Proposed typical floor plan - Buildings 7 and 8

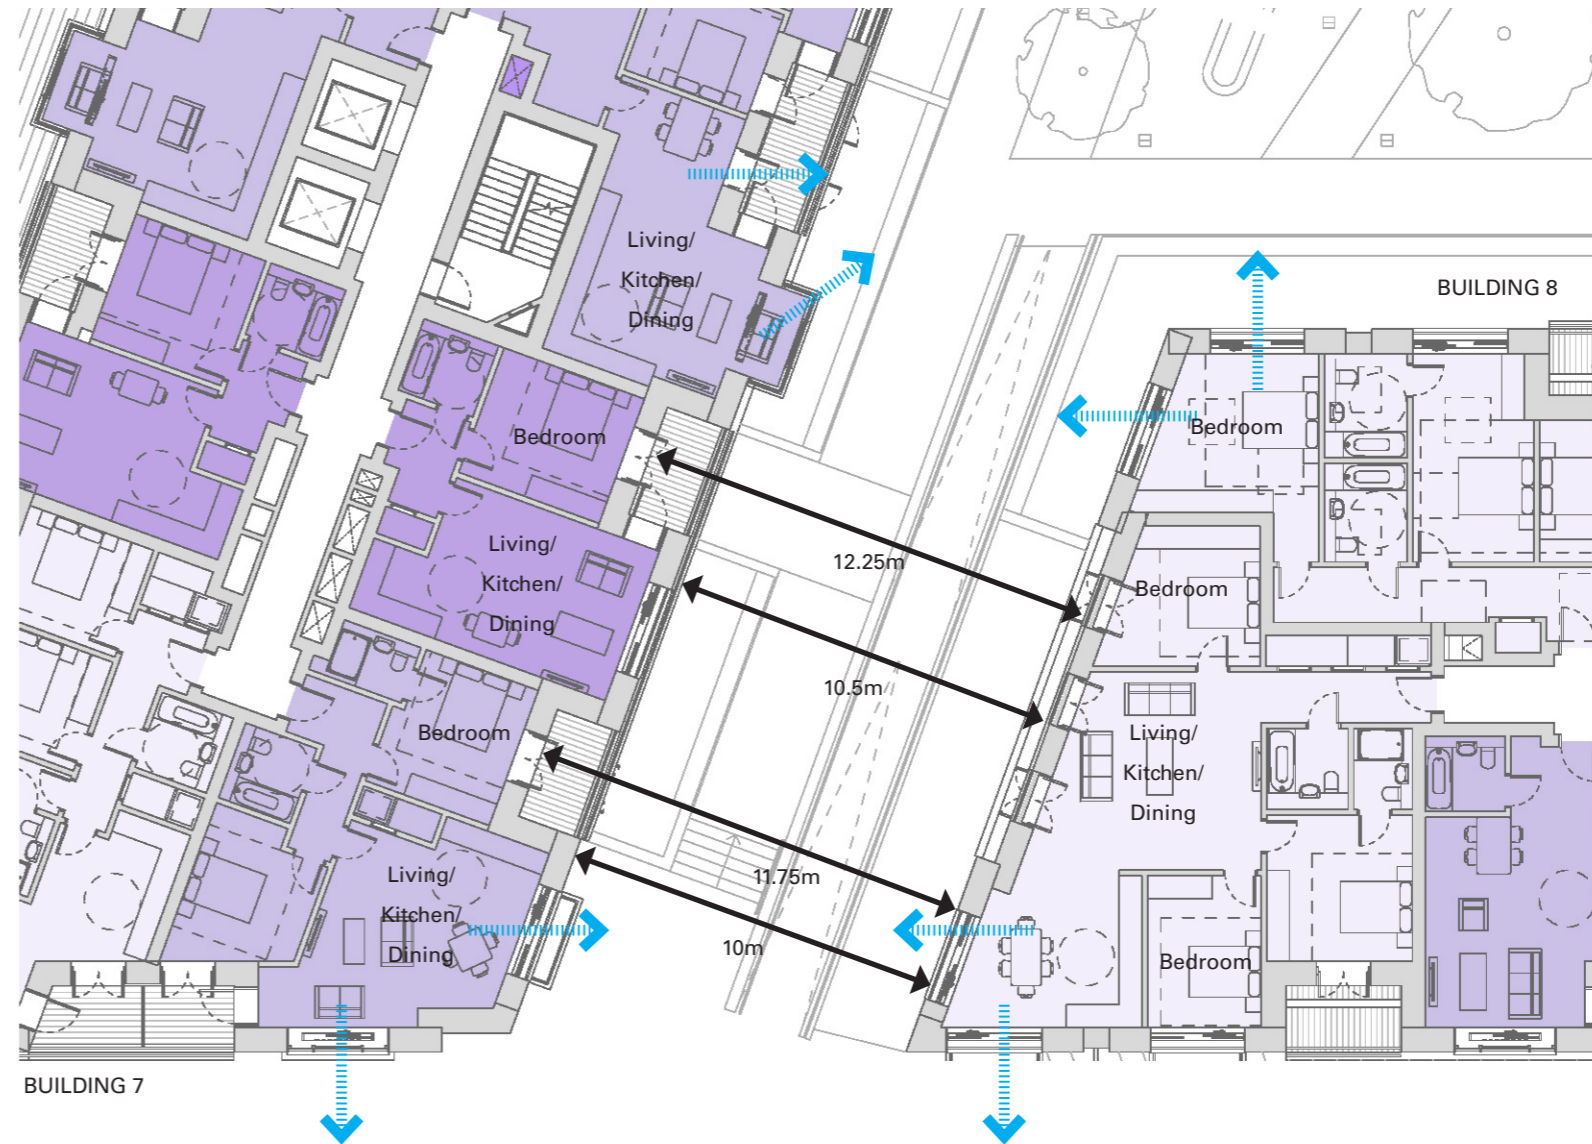
4. Block 8 with 11: Only 15m gap and single aspect. Why acceptable.

5. Block 8 with 7: Only 10m gap. Unacceptable living conditions.

Please see section dedicated to 'Proximity of Buildings'.

Please see section dedicated to 'Proximity of Buildings'.

Proposed ground floor plan - Building 9

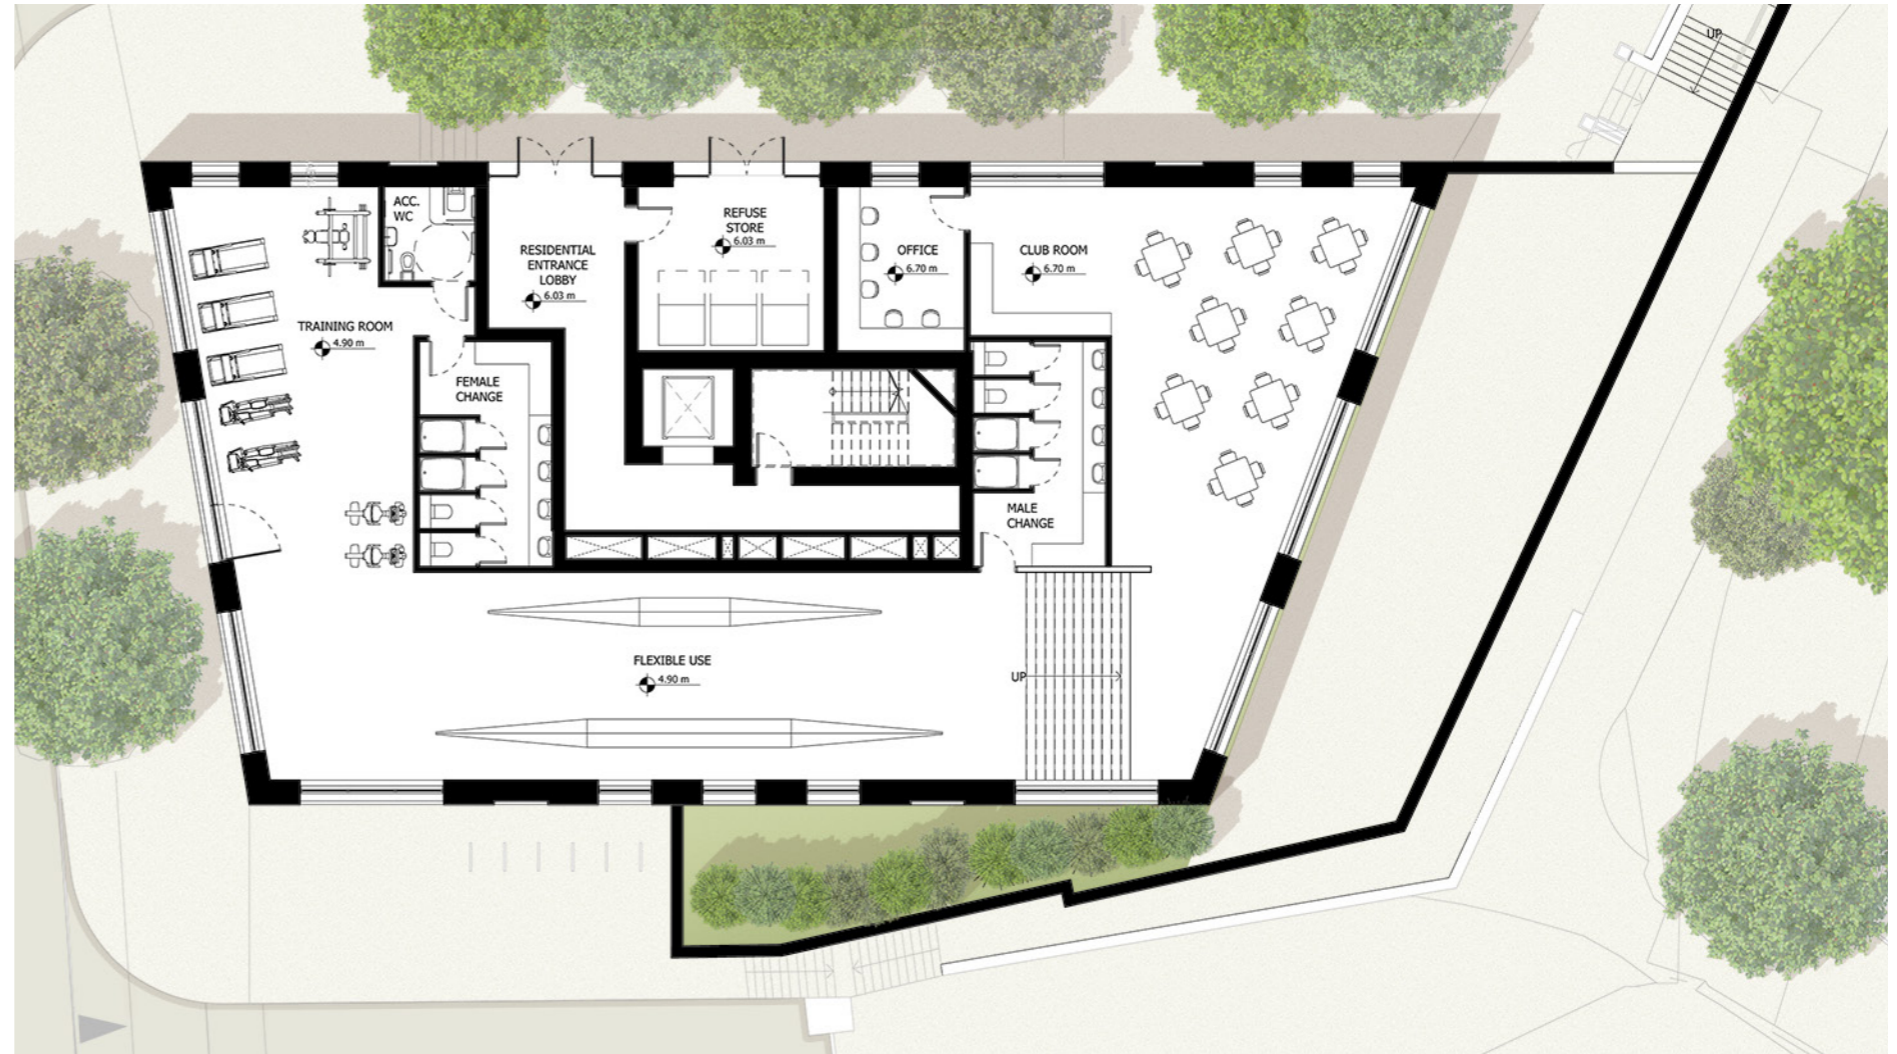
1. Provide updated elevations.
2. Provide section through, showing level changes from floor to river.
3. Removal balustrade at roof level.

4. Ensure plant is at centre of roof level.

The proposal for Building 9 has been altered to respond to comments from the environment agency regarding current and future flood risk. The revised proposal provides a means of defence along the building façade as opposed to within the ground floor of the building. The proposal also incorporates a raised terrace area, beneath which a storage area for rowing boats (or other water sport equipment) is proposed to provide ease of access to the existing slipway. The balustrade at roof level was proposed as a means of edge protection (from risk of falls) to any maintenance personnel when accessing roof top plant. We would not recommend removing this balustrade since this would pose a health and safety risk.

The roof top plant has already been configured in a manner that provides minimal impact to the appearance of the building. The parapet level facing Mortlake High Street masks the roof top plant from view.

Revised north elevation - Building 10

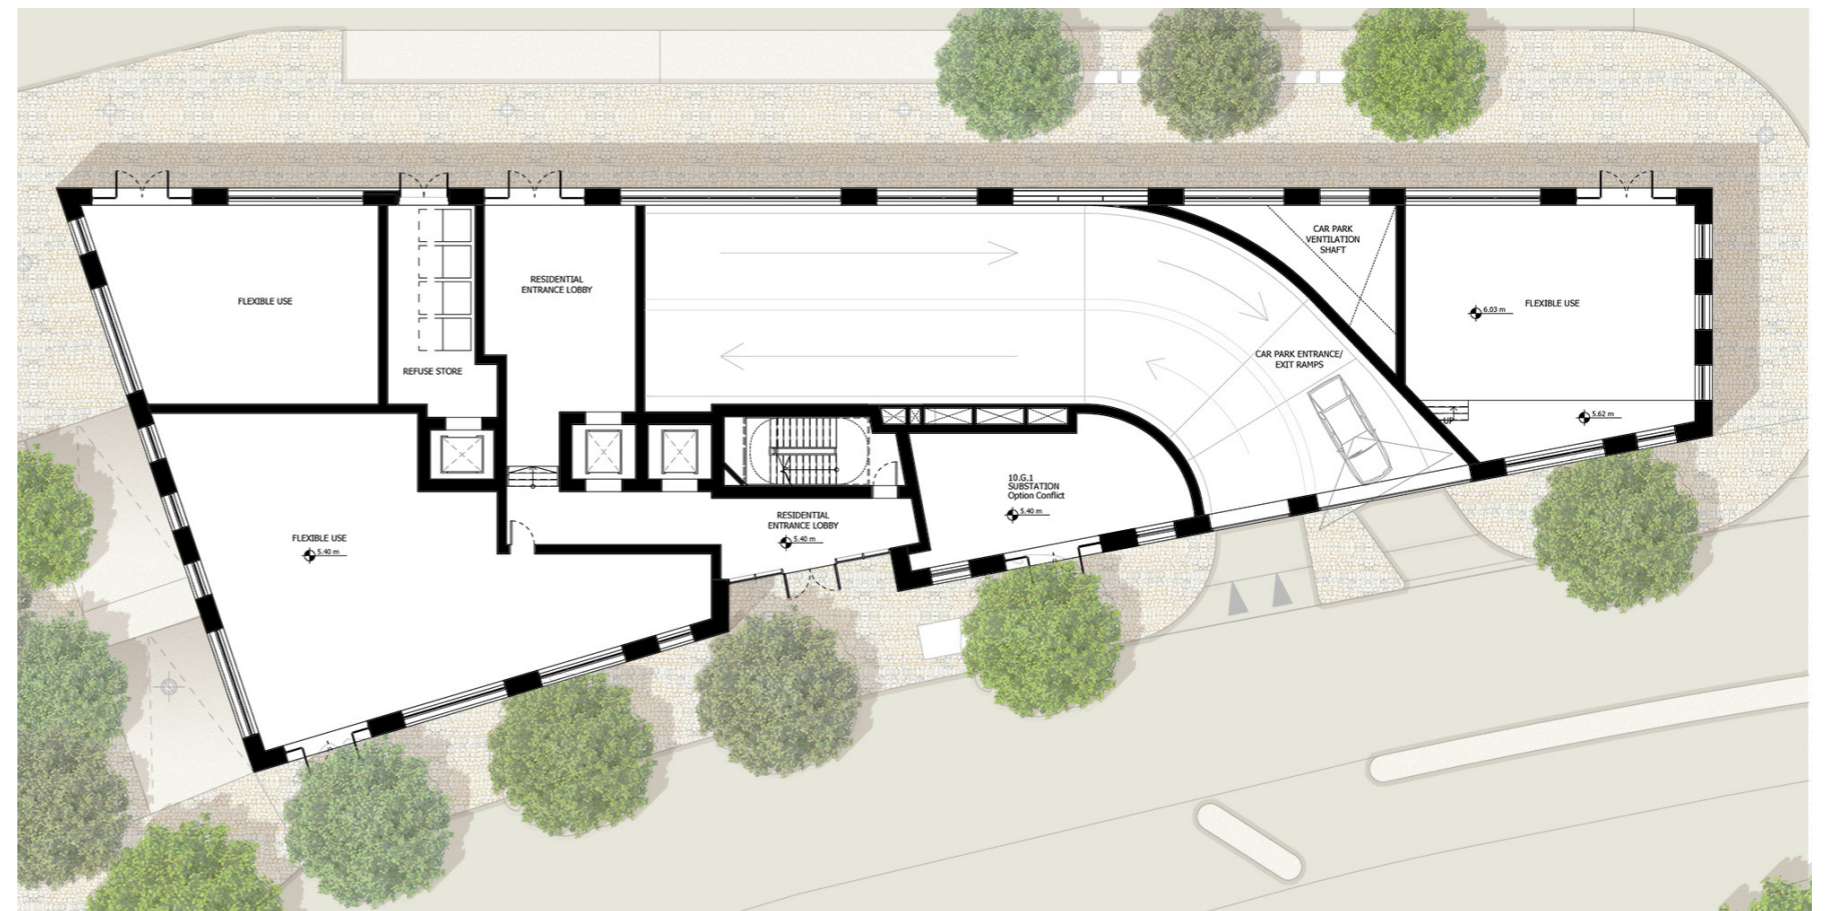
1. North elevation 'dead frontage'.

2. South elevation – broken up with glazing. This works successfully – something more radical is needed for Block 7 in particular.

3. Poor frontage on south elevation – entrance, substation, rear of flexible uses and car park.

The 'dead frontage' is caused by the ramp access to the car park. This access location is constrained by existing highways circumstances and by technical issues relating to the ramps fall and turning radius. Unfortunately, there is very little that can be done to reduce the impact of the ramp (i.e. by moving location of and/or reducing length of the ramp) other than to provide obscured glazing to these openings. The obscured glazing could incorporate advertising and/or public notices and the design of these features could be conditioned.

We believe that it would be inappropriate to break-up the length of mansion Building 7 with a glazed link. We have carefully crafted a contemporary version of the historic mansion typology that was extensively built during the Victorian era to deliver extensive new housing stock to a higher density. We believe the glazed link (which would need to be at least seven storeys high) would sit uncomfortably with this already very varied and undulating elevation.

The ground floor level of this building is constrained by technical requirements (see response to item 1), however we have endeavoured to introduce amendments to increase width of glazing to flexible use units.

Proposed typical floor plan - Buildings 10, 11 and 12

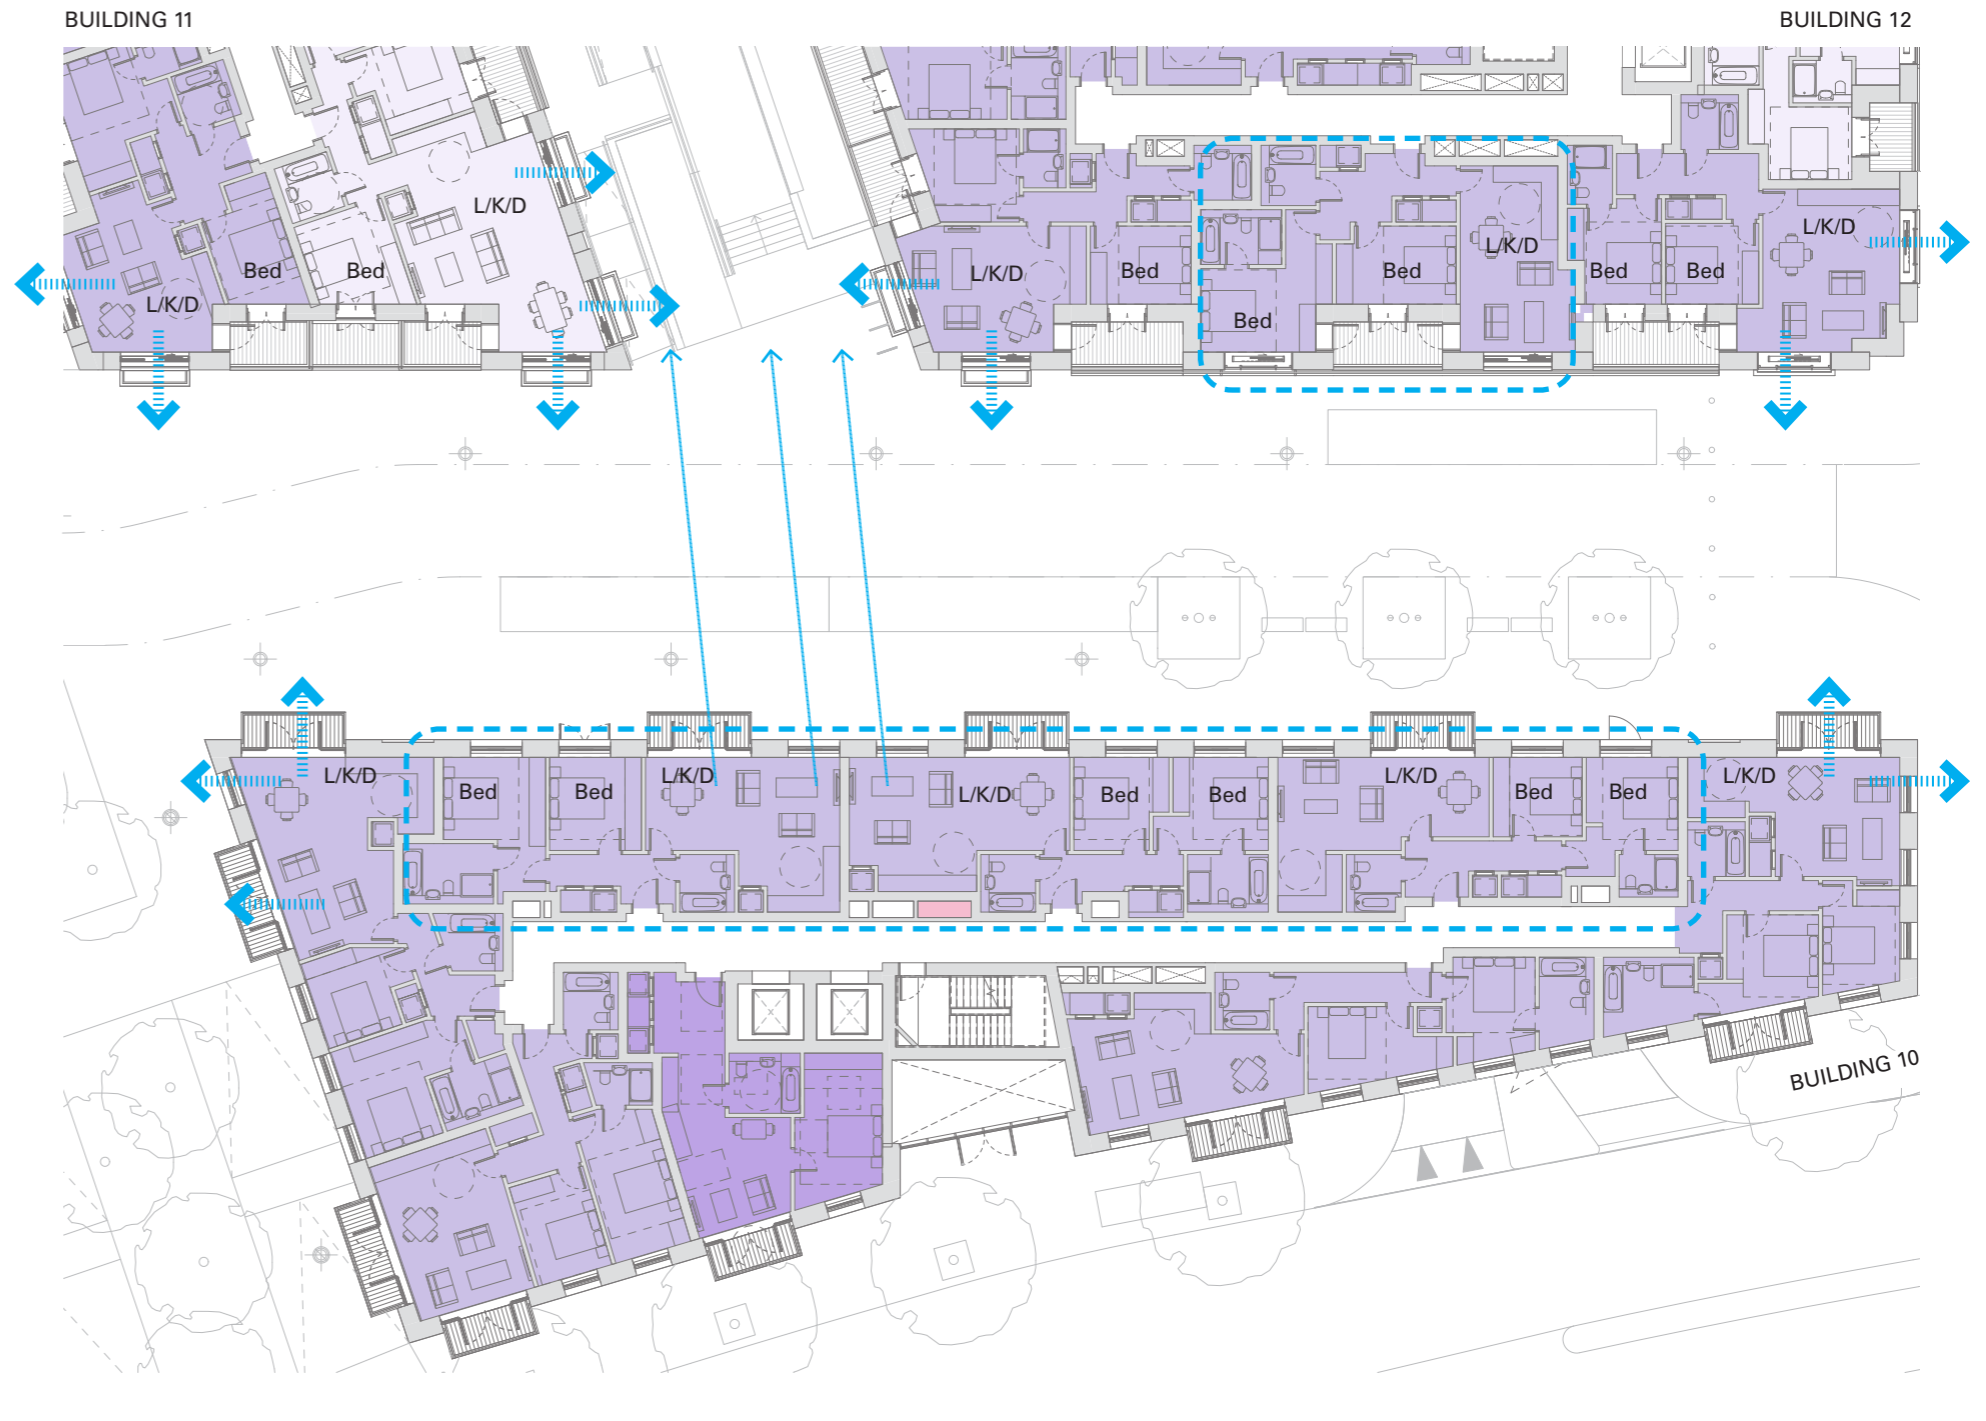
- Block 10 with 11 and 12; only 13m and incorporates north facing single aspect units.

- Surrounding blocks (5, 11, 12 and 9) are only 13.5 – 15m from the facades. All such distances fall below the 20m standard for privacy levels – how will the scheme prevent unacceptable overlooking, and ensure that flats are not overbearing to future occupants.

Please see section dedicated to 'Proximity of Buildings'.

This building transitions between the two geometries of Mortlake High Street and the proposed new Thames Street route. The result is a very long, narrow and tapering building shape. As previously explained, the car park entrance ramp has had to be located in the base of this building (due to highways constraints) and this route cannot be interrupted by structural columns and/or vertical circulation cores. The vertical circulation core has been deliberately located to avoid disrupting the ramp, however this means that corridor access and single aspect units are required to make this building feasible as a residential building.

Please see section dedicated to 'Proximity of Buildings'.
